RE: Request for Amendment, North Butte and Ruth ISL Projects - License SUA-1540

PATHFINDER MINES CORPORATION
REQUEST FOR AMENDMENT TO SUA-1540, DOCKET NO. 40-8981

Revise Description of Project Owner

Figure 15.21

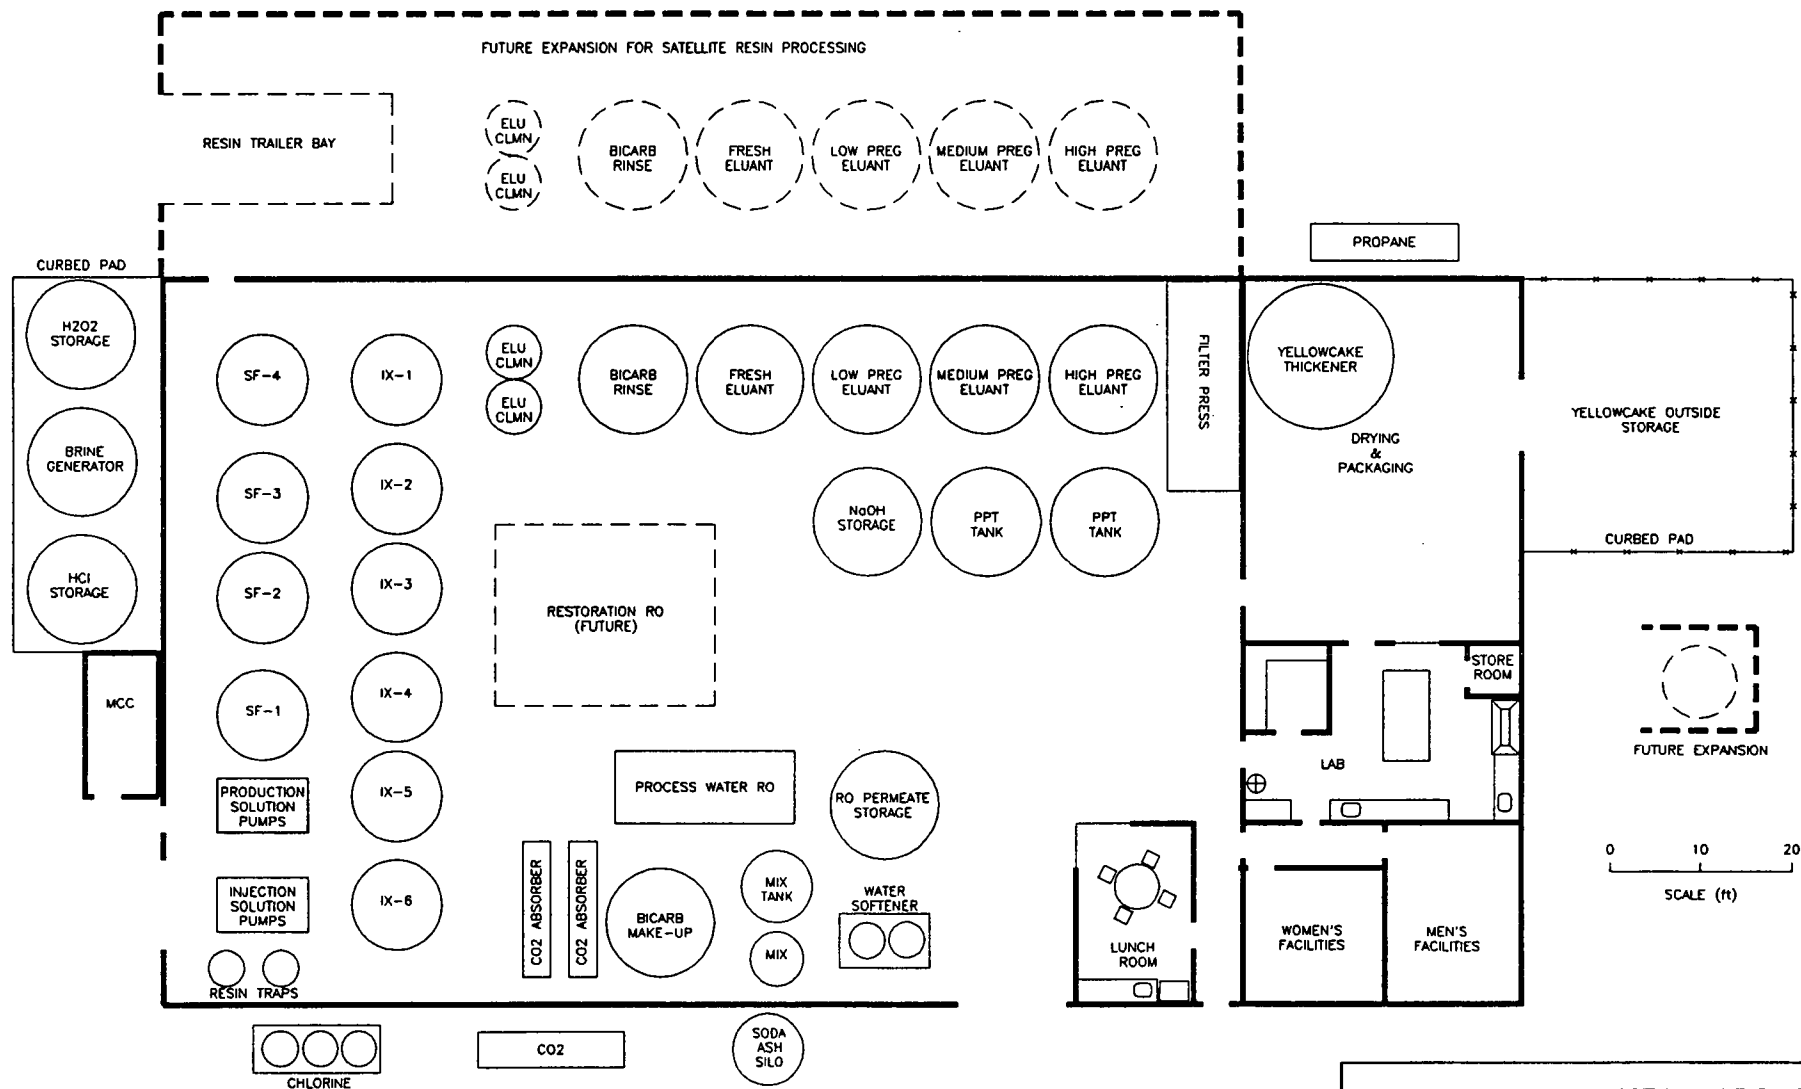
12	Figure 15.21 of the North Butte application has been revised to indicate Pathfinder's plans for the process building and equipment layout. Additionally, Figure 15.22 (Process Flow Sheet), has been revised to show more detail including the increase in flow rate to 4,000 gpm, the deletion of surge tanks, the addition of sand filters, and the addition of chlorine to the injection solution for bacterial control. The new Figure 15.22 fulfills the requirement of Condition 12 for submittal of detailed flow diagrams three months prior to construction. These revised drawings are contained with the Index and change package for process changes.	"Any significant changes in the process circuit as shown in Figure 15.21 of the North Butte application dated <u>April 1, 1992</u> , and Figure 15.19 of the Ruth application dated October 3, 1988, shall require approval by the NRC, Uranium Recovery Field Office in the form of a license amendment. " <i>(delete remainder of condition)</i>

Pathfinder has also incorporated a detailed process flow sheet as well as a new plant layout drawing. The changes to the previous process flow sheet are the flow rate of 4,000 gpm, the addition of sand filtration prior to ion exchange, the deletion of surge tanks (wellfield pumps are capable of sending solutions to the plant), and the addition of small amounts of chlorine gas to the injection solution to prevent bacterial invasion in the injection wells and the plant equipment. Additionally, although not indicated on the flow sheet, air vents will be located on each injection well to alleviate pressure buildup from oxygen exhalation during operations. The new plant layout provides our current estimate as to where the plant circuits will be located within the building, which has been downsized from the previous Uranerz design.

Most of the process equipment will be housed in an approximate 80 ft. by 150 ft. metal building with 20 ft. eaves height. As shown in Figure 15.21, the majority of the chemical storage tanks will be located outside the process building. Pathfinder has no plans to use surge tanks at this time.
